ADDENDUM No. 1

RFP No. 22-26

Street Resurfacing Project - 2022

SHEET No. 3 OF 61

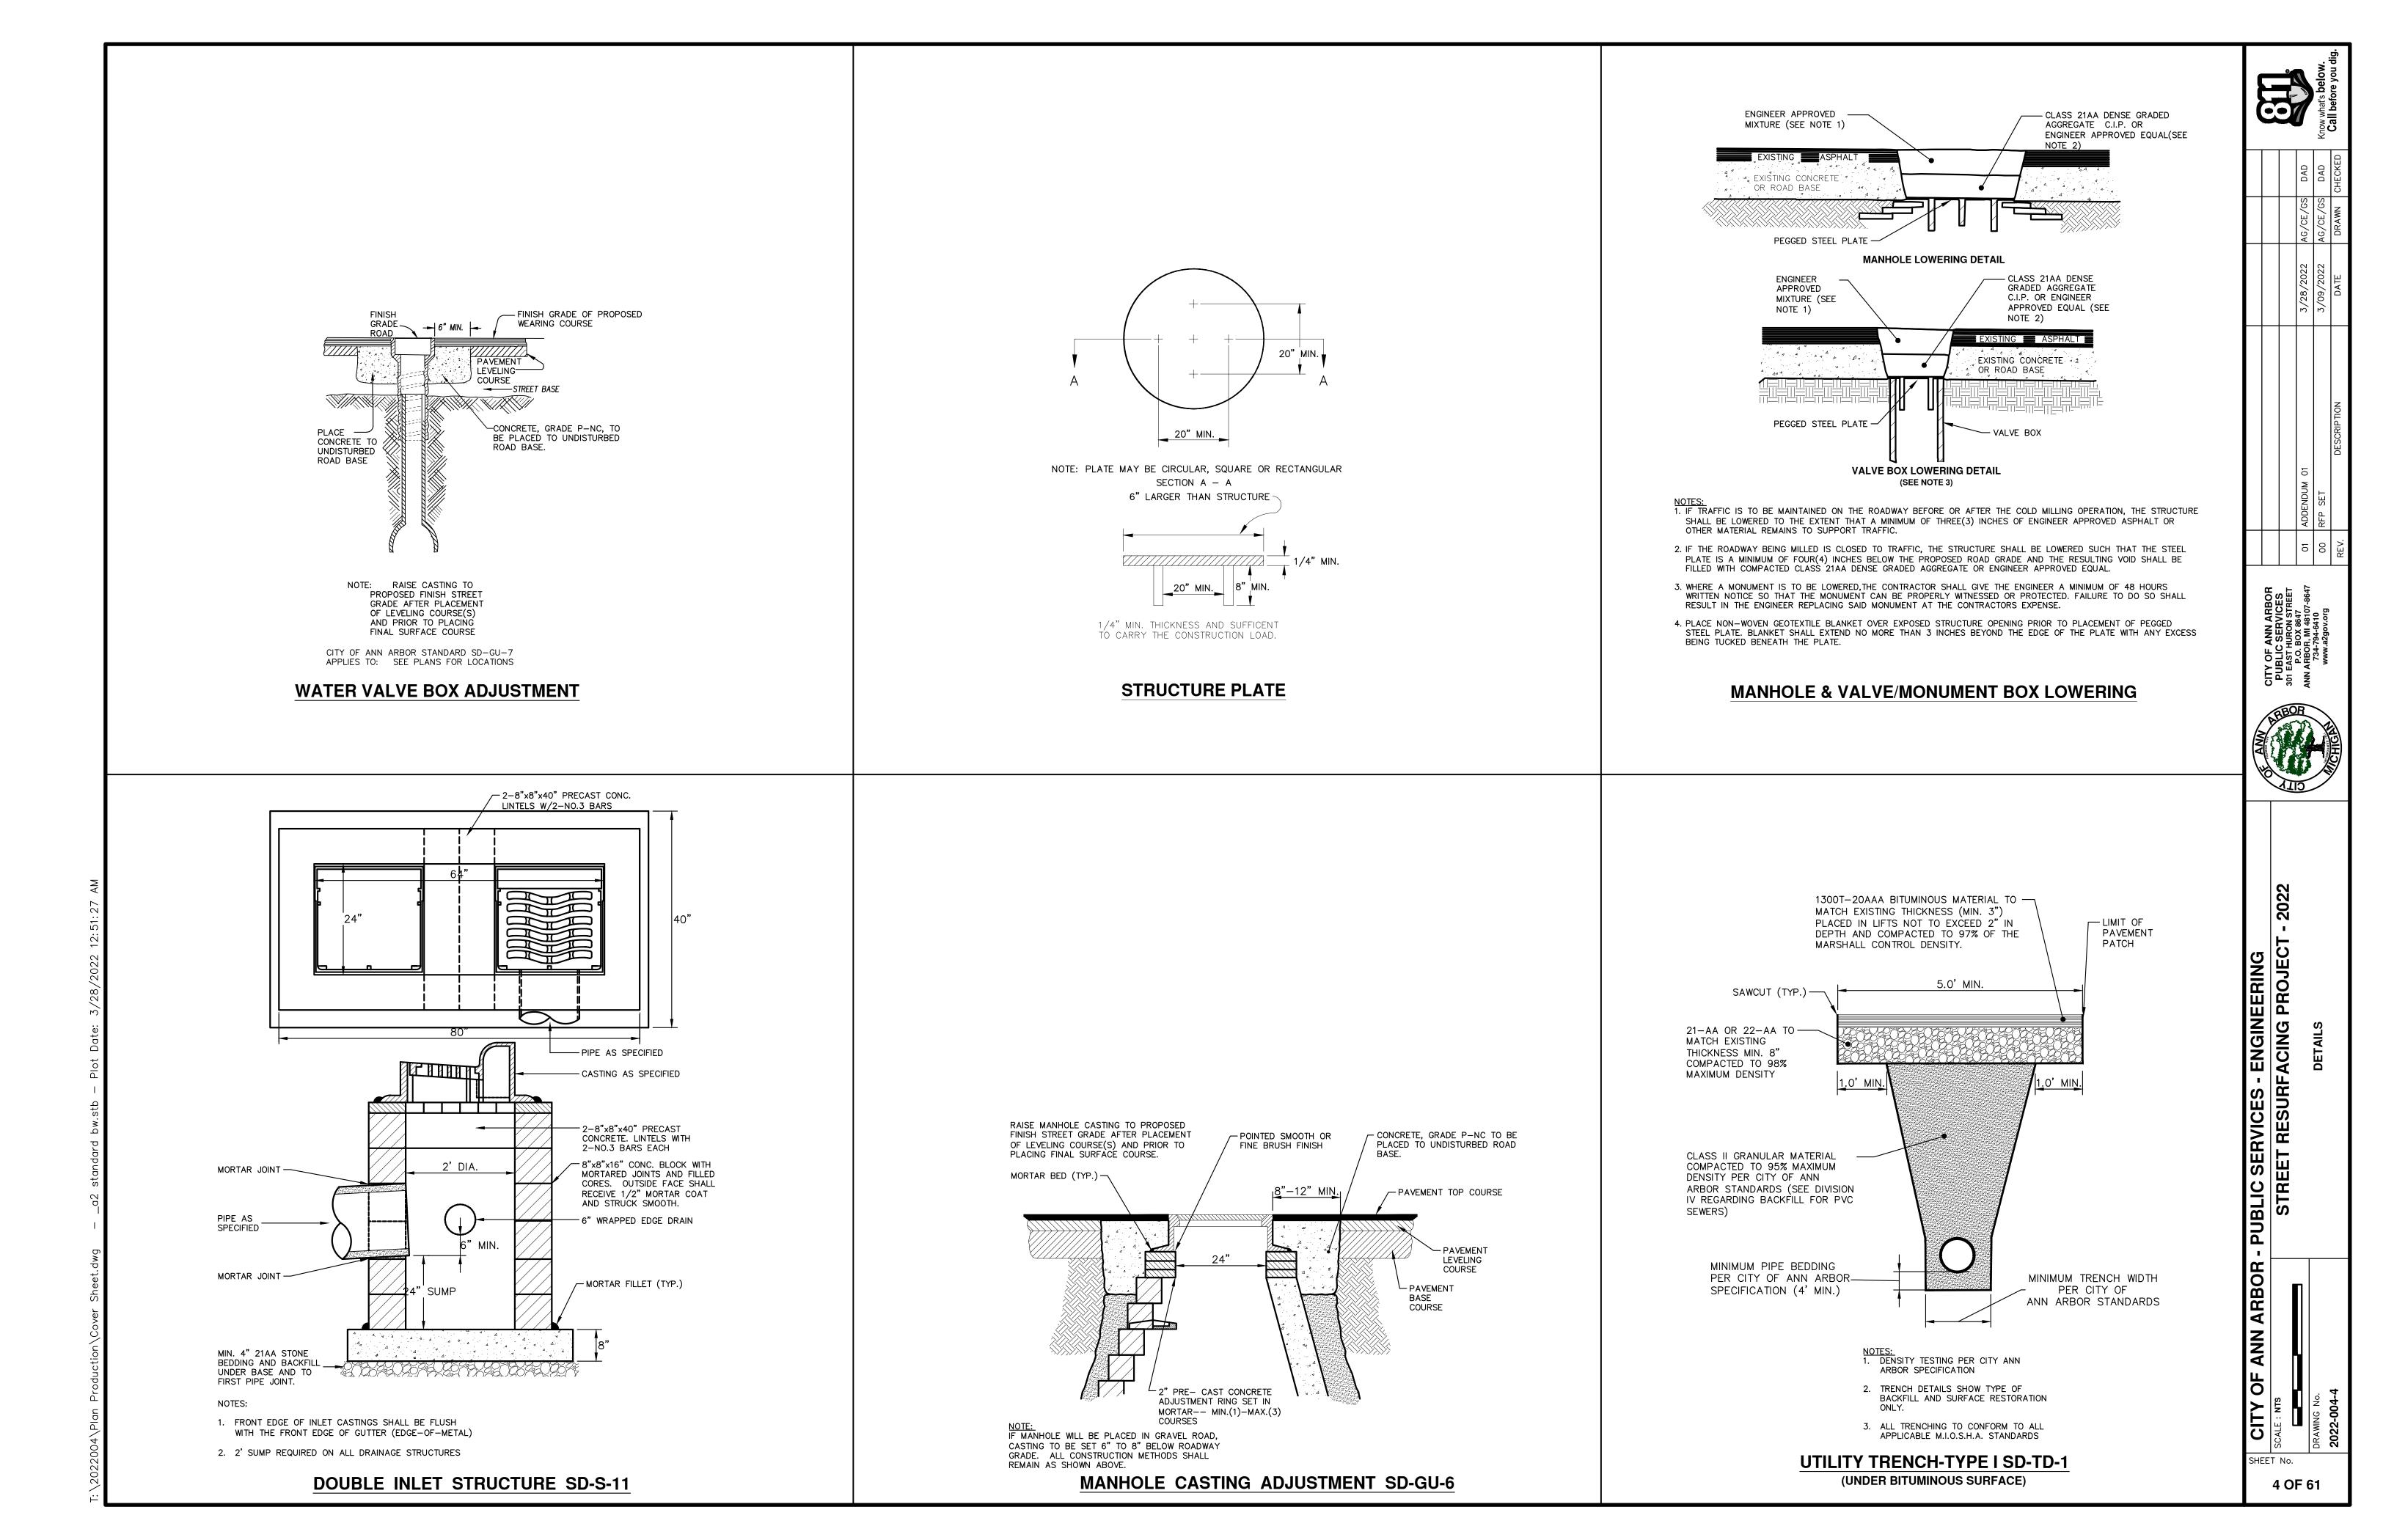
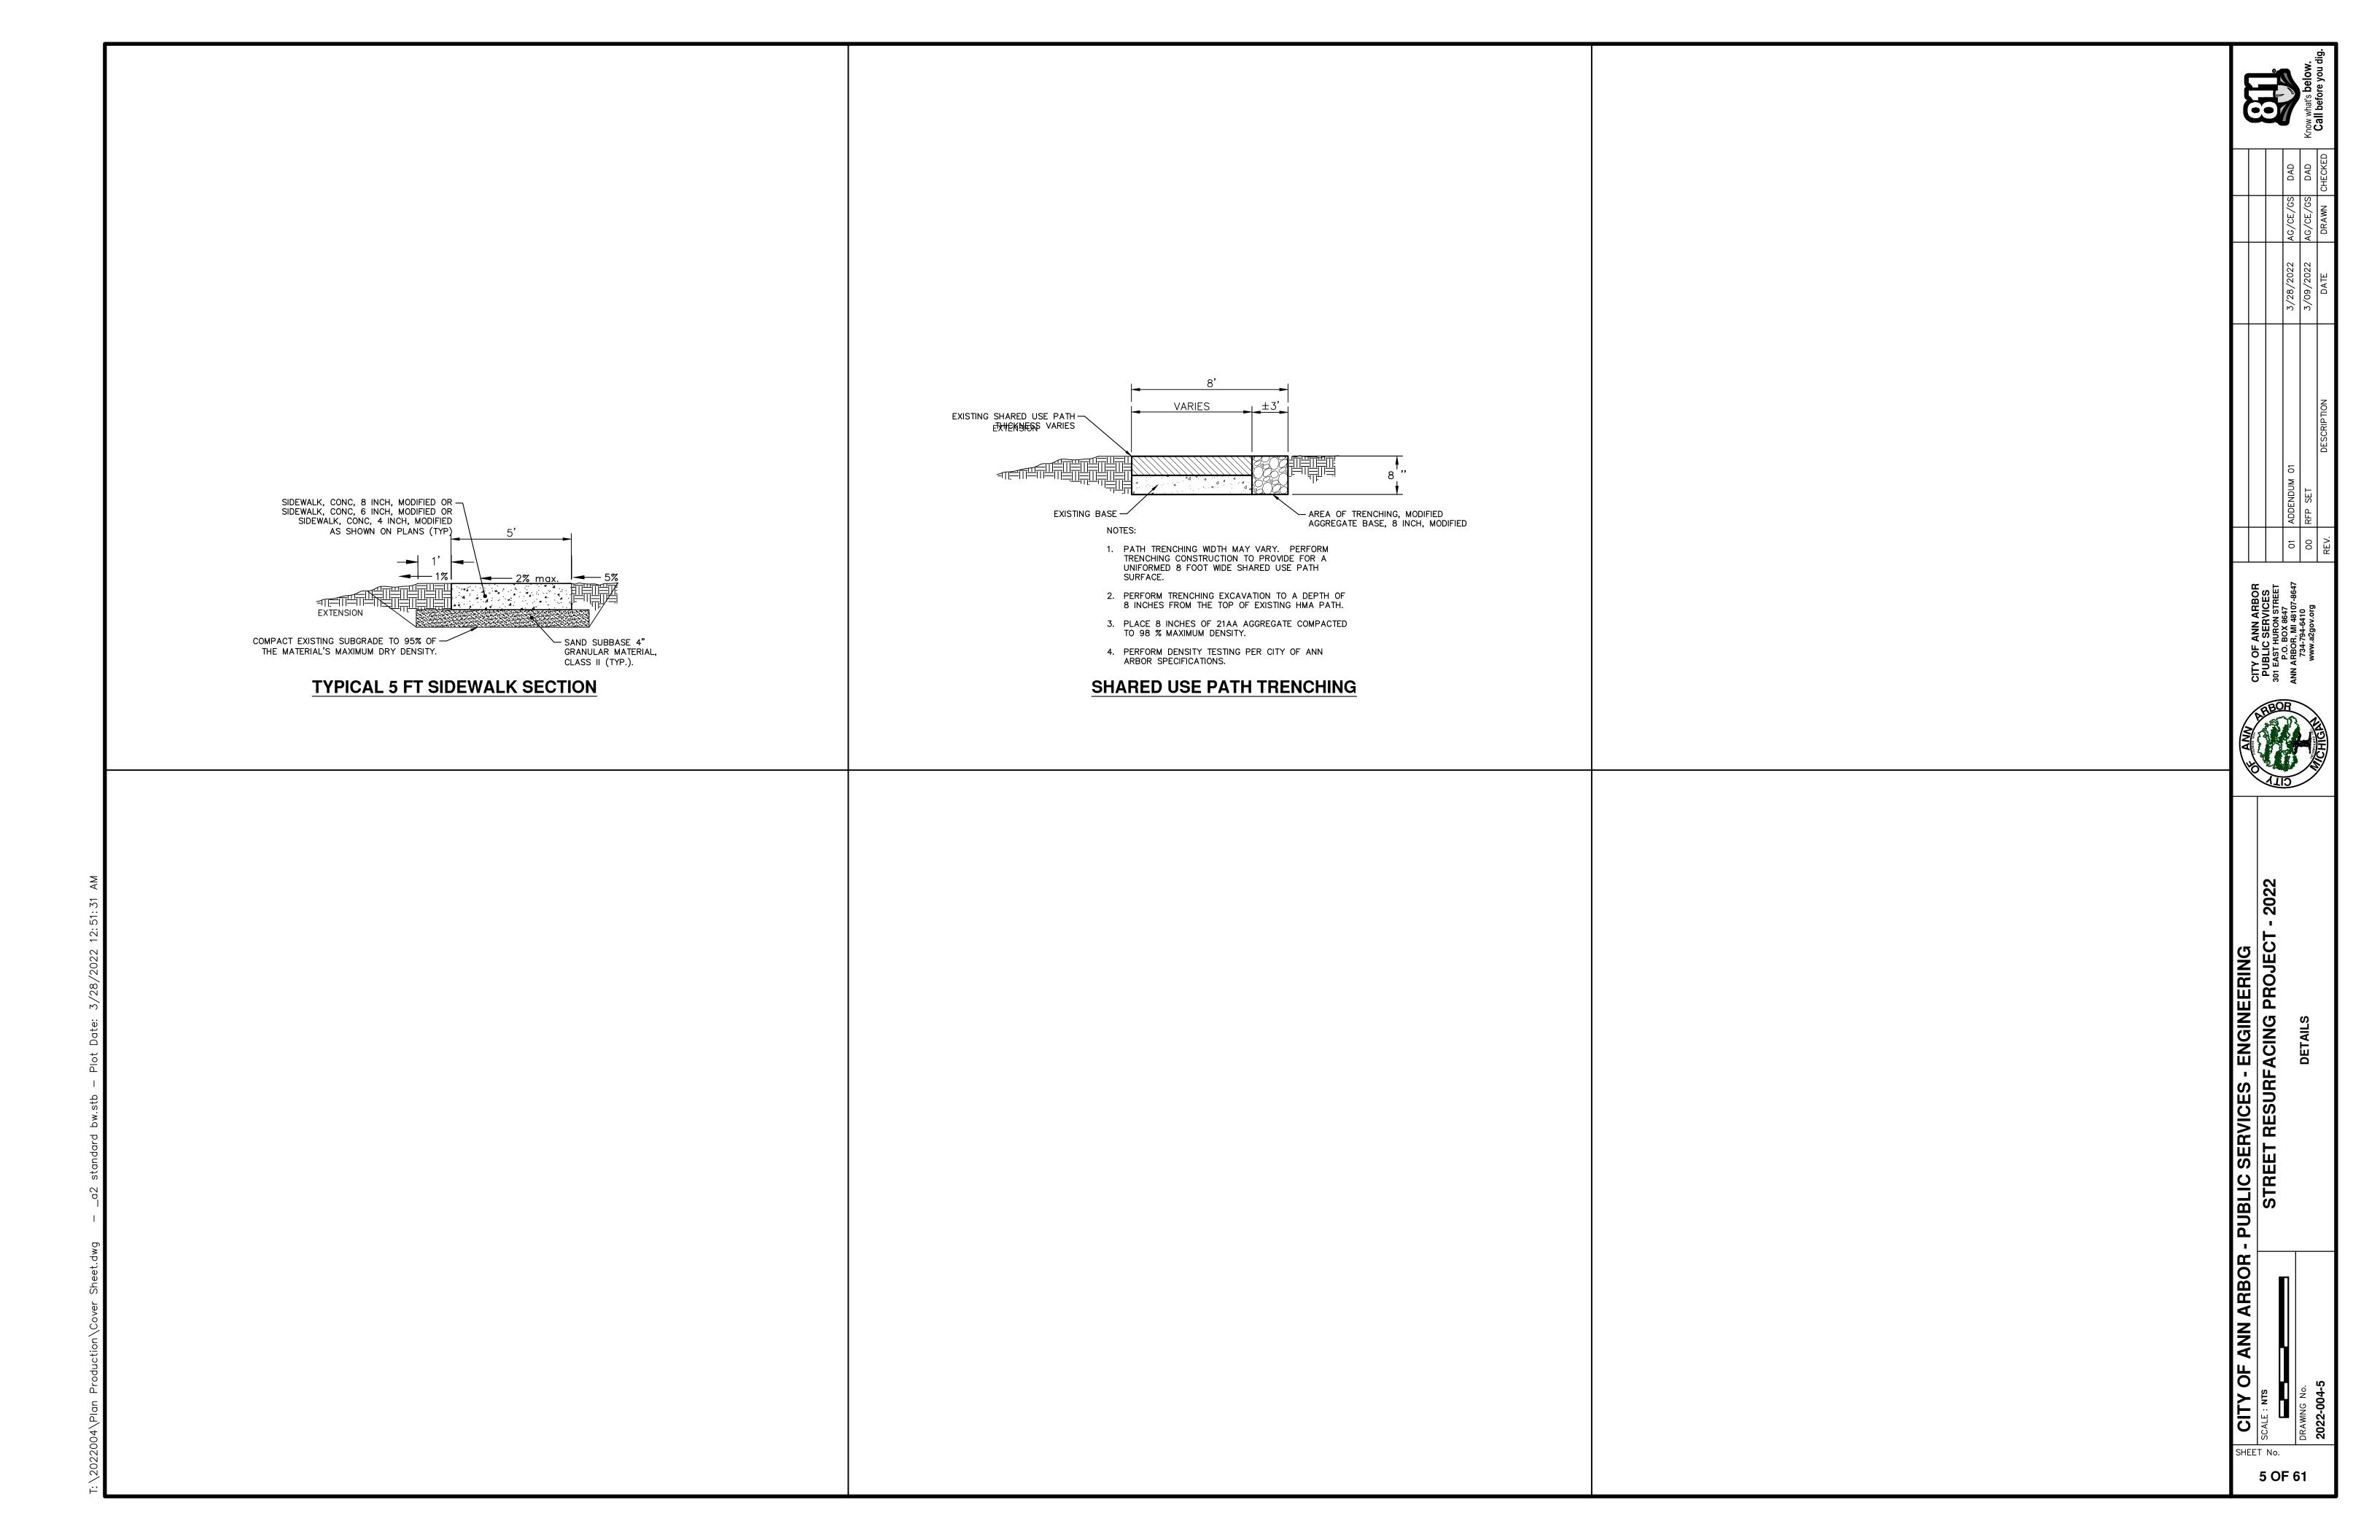
Sheets 3-5 Reorganized details applicable to project. Revised structure

6 OF 61

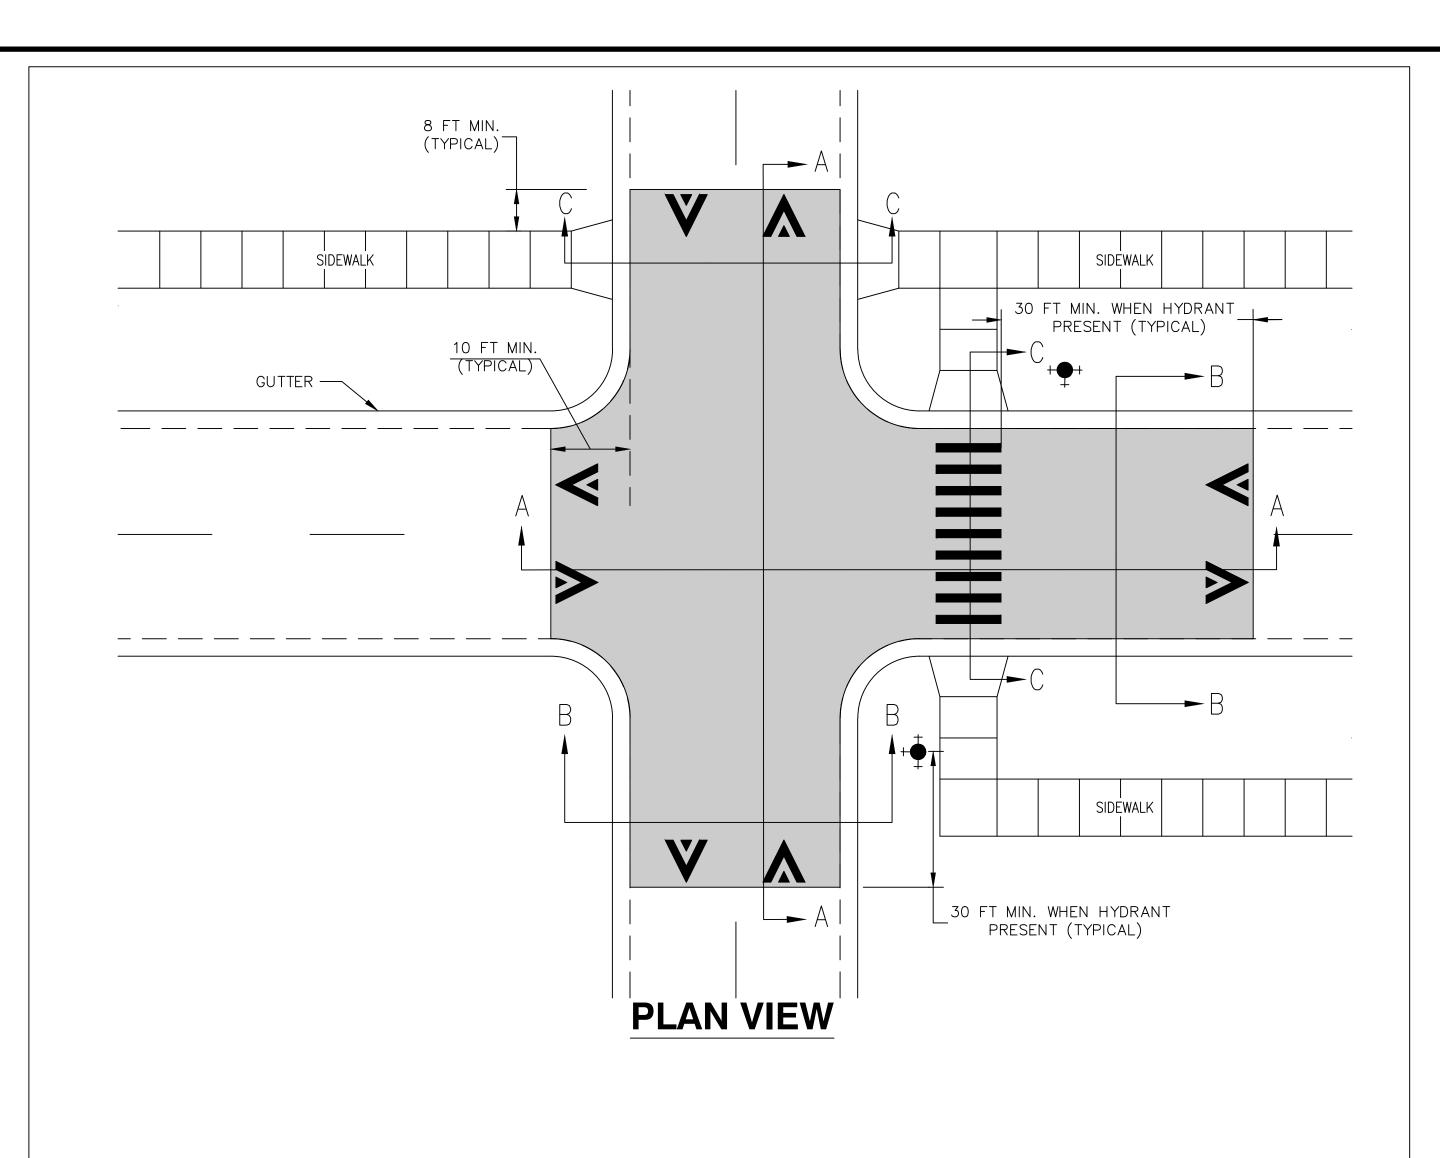
Sheet 6 Revised notes and added street listing for those that will
